## RECALL 16V-553: HEAD PROTECTION SYSTEM

This Service Information bulletin supersedes SI M65 07 16 dated July 2016.

F54 MINI Clubman
------------------

#### M650716 Recall Head Protection System

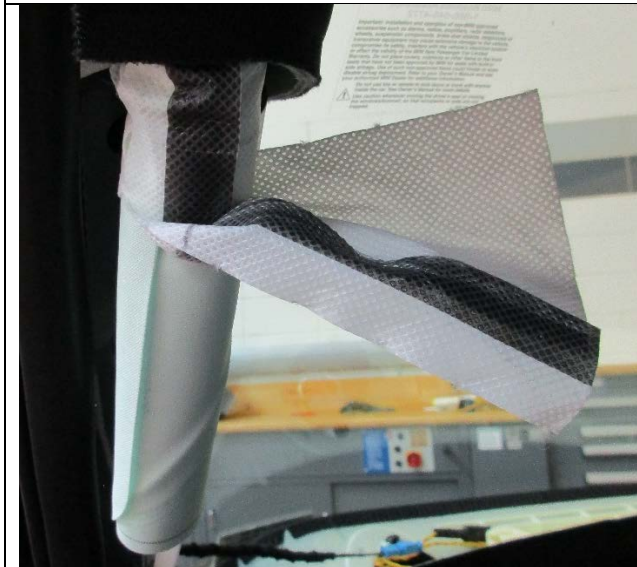
4. Squeeze the air bag package into an oval shape. This will enable it to clear the metal bracket.

5. Using a metric ruler, mark exactly 80mm up from the bottom of the air bag package.

6. Tear open the wrapper, at the split line, from the end of the air bag up to the 80mm mark.

7. Fold the wrapper part that needs to be cut 90° out for easy cutting.

8. Using the round tip scissors, cut off the end of the wrapper at the marked 80mm split line.
